# Hopemead State Park Recreation Area

Montville, Connecticut

## EASTERN CONNECTICUT ENVIRONMENTAL REVIEW TEAM REPORT

February 1996

Figure 2

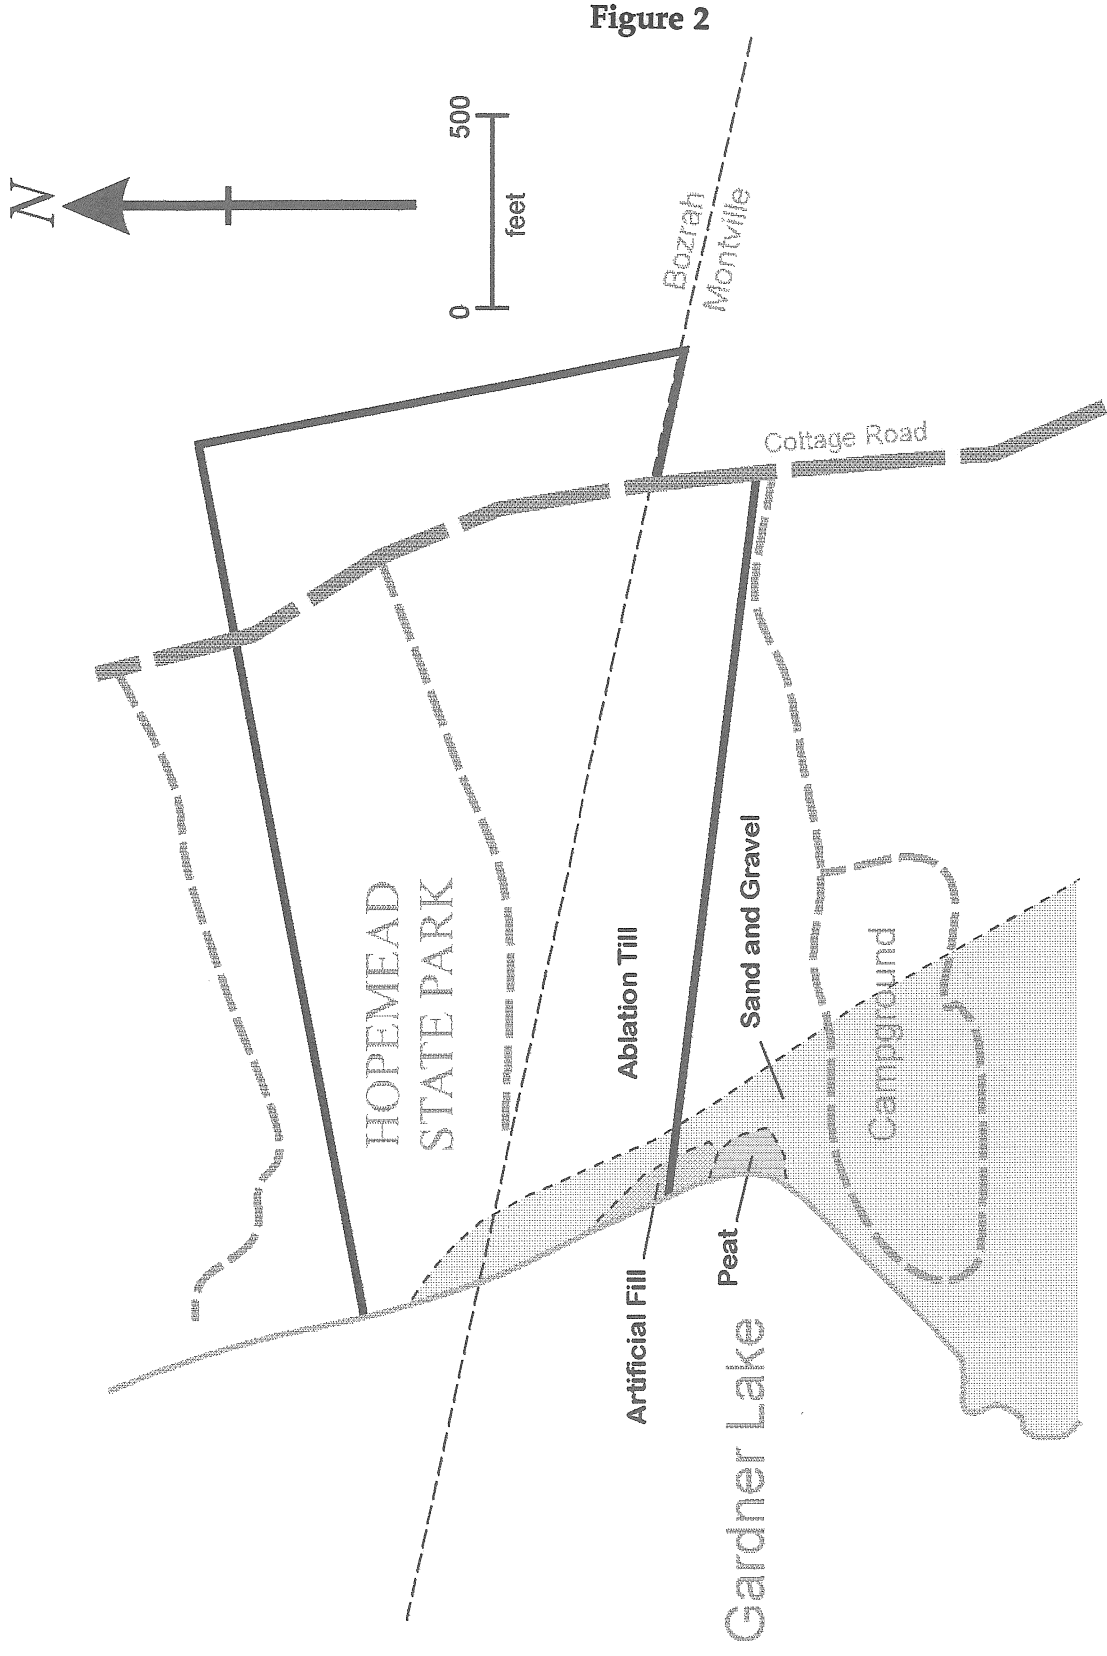
The published Surficial Geology map of the Fitchville Quadrangle (USGS GQ-485, Pessel, 1964) shows the flat area east of Lake Gardner underlain by glacial till, a poorly sorted material composed of ground-up local bedrock material deposited either directly at the base of the last continental ice sheet or debris unceremoniously dumped by debris laden ice as it melted. The flat featureless form of the surface, which is quite unlike hilly till covered terrain elsewhere in the Fitchville and Montville Quadrangles suggests the surface deposits in Hopemead State Park formed during melting. Indeed it is likely that an ablation till accumulated as blocks of ice melted in stagnant water which ponded behind the east-west bedrock ridge formed by Forsyth and Raymond Hills at the south end of Oxoboxo Lake. Once the Oxoboxo Lake outlet was cleared of ice, the now rapidly flowing melt waters deposited sand and gravel (so-called ice-contact stratified drift) along the edges of the remaining ice. One such block occupied the low area which is now by Gardner Lake, and the edge of the former ice is now marked by the steep slope along its shoreline. The escarpment is veneered by a narrow ribbon of coarse angular sand and pebbles which although not shown on the Surficial map is the extension of thick stratified drift on the campus of the Thomas More School (QC1 on the surficial map). The fact that the site of the proposed town beach is underlain by coarse sand and gravel should simplify any excavation and regrading and minimize the amount of sand that must be imported. As the area has been previously disturbed by landscaping for the original Hopemead Estate and during construction of the beach at the campground, the town beach would not be expected to cause any more physical environmental damage than that done 50 years ago!

Figure 3

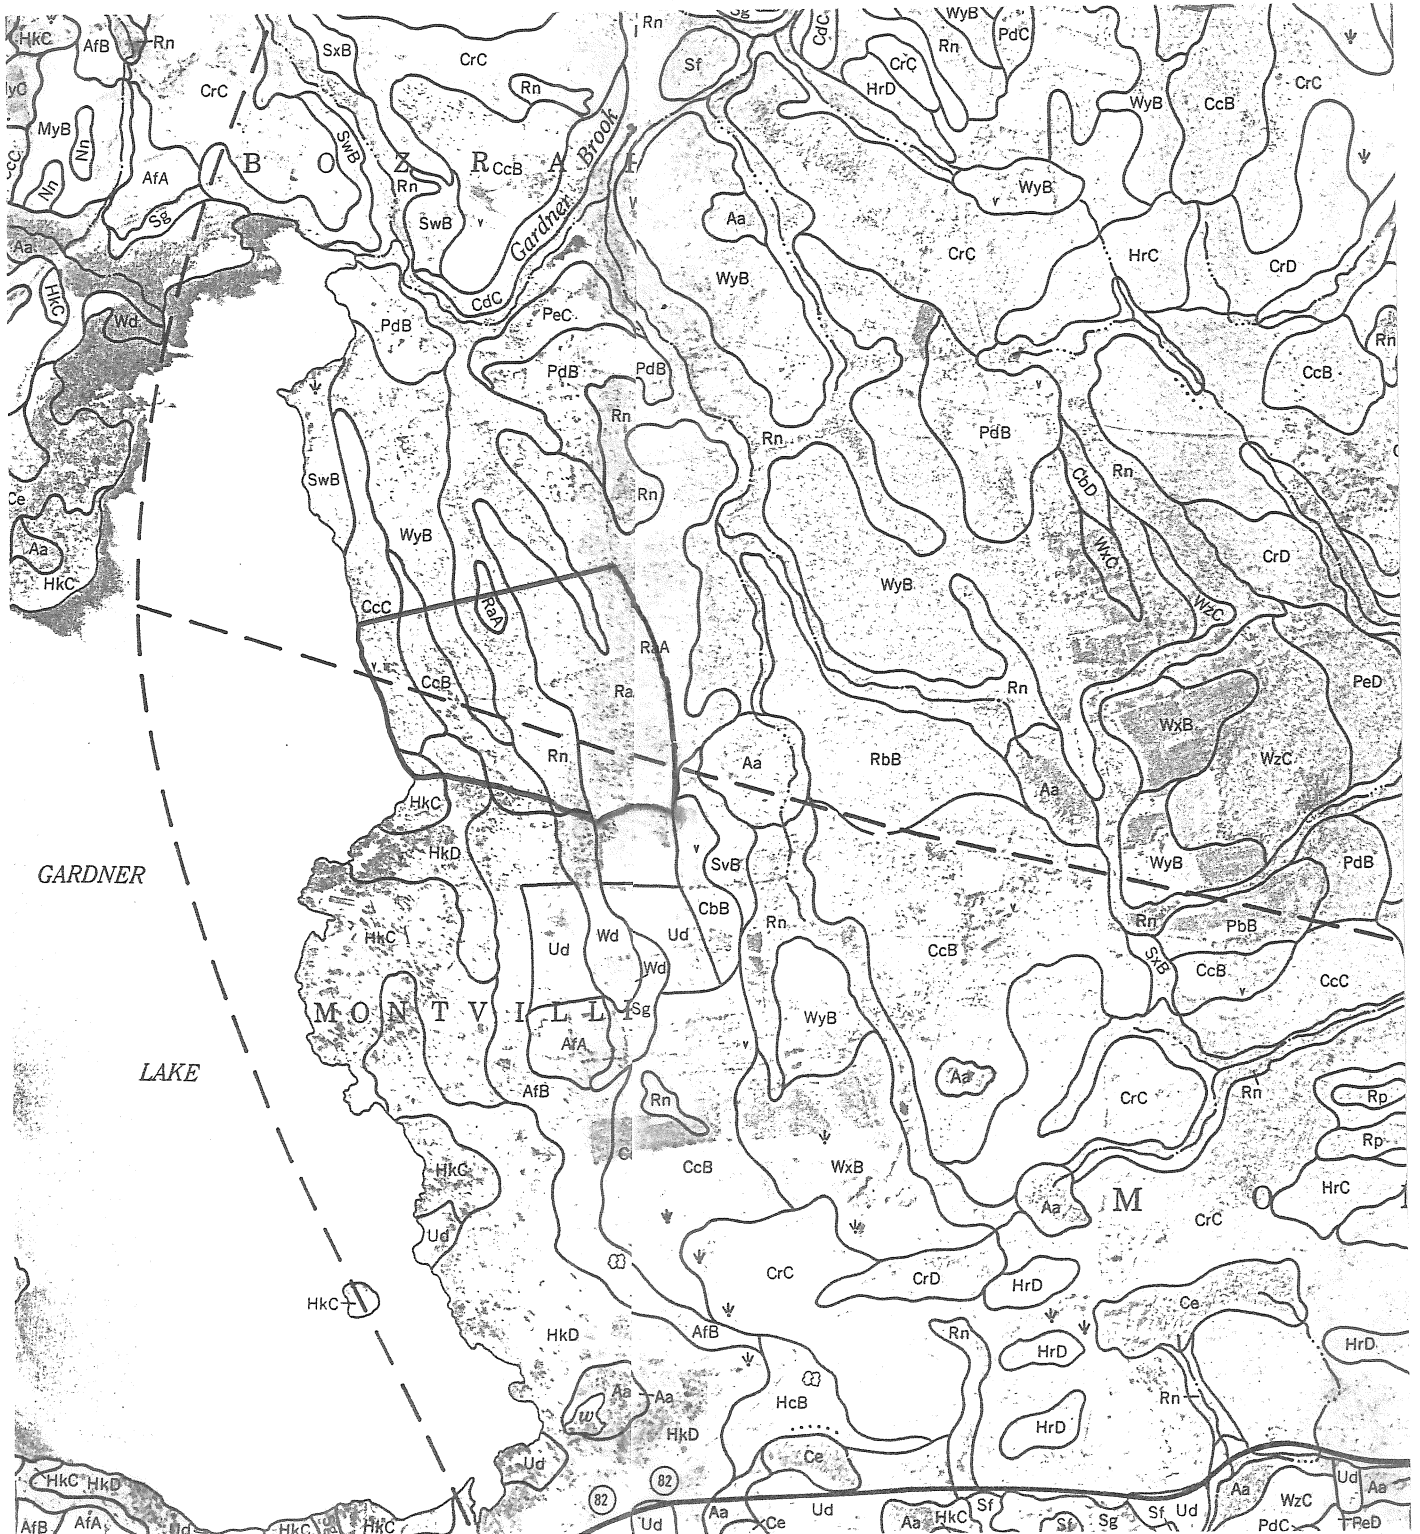
There are a couple of eroding spots near the proposed beach area. Foot traffic, steep slopes and lack of vegetation, which seems to have resulted from previous disturbances, are the main reasons for the erosion. Restricting access to these areas and stabilizing the slopes by restoring vegetation should control these problem areas.

The plans for an access road are to add gravelly material to the existing road and to clear a few pull out spots to allow for vehicular traffic in both directions. The existing road seems to be in good condition. The proposed changes should allow for school buses to use the road, and prevent wetness problems. The wetlands crossing should be improved by installing an adequate culvert.

The road is relatively flat and as long as it is dry it should be suitable to vehicular traffic, especially if it is only used during the summer. As the road approaches the lake shore it gets very steep. This would limit its use for vehicular traffic. To prevent erosion problems on the road and to avoid potentially difficult driving conditions, vehicular traffic should be constrained to the flatter sections of the road. Therefore, the proposed parking area should also be moved east to facilitate access from the road.

The development of a beach area would be difficult because of the steepness of the shore area. The proposed beach area is small (around 125 ft. length x 75 ft. width) and is located on a flatter section of the shore, but the areas surrounding the site are much steeper, which creates difficult working conditions. Some sedimentation during construction should be expected, but should not be considered a major concern as long as erosion and sediment control measures are taken.
